Serial No.: 10/802,409

Amendments to the Drawings:

REMARKS

FIG. 2

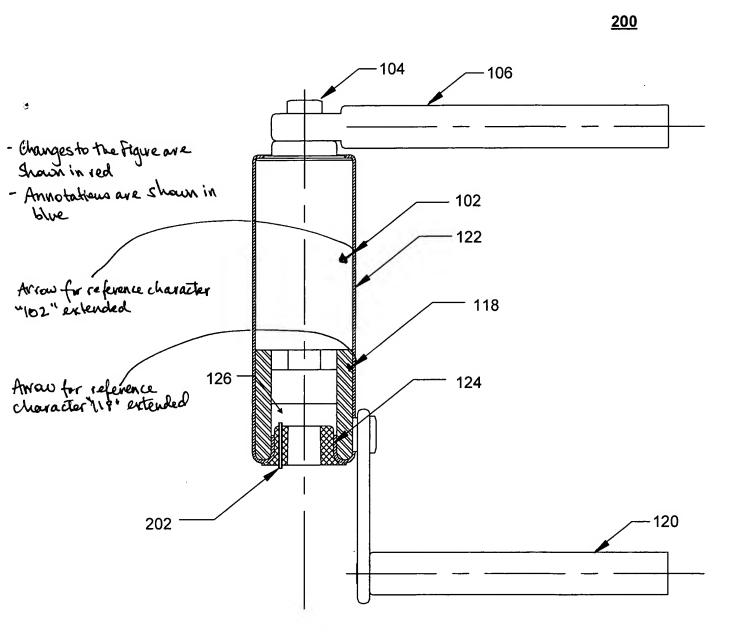
In Figure 2, the arrows pointing out the portions of the figure that refer to reference characters 102 and 118 have been extended to more precisely indicate the items to which they refer.

In response to the Examiner's objection to Figure 2, applicant has amended Figure 2 such that the arrows for reference characters 102 and 118 have been extended to more precisely indicate the elements to which they refer. The Examiner objected to reference character "12" in Figure 2 as being one of three character references that identify the "sleeve" in Figure 2. See the Office action of Dec. 1, 2005 at page 2, lines 6-8. However, Figure 2 does not include a reference character "12." As such, applicant assumes that the Examiner intended to refer to reference character "112." Reference character 112 refers to the sleeve and no change for this reference character is needed.

The attached replacement sheet of drawings includes changes to Figure 2 and replaces Figure 2. The attached annotated sheet shows annotations indicating the changes made to Figure 2 and explaining the changes. In the annotated sheet, the changes are indicated in red ink and the annotations are shown in blue ink.
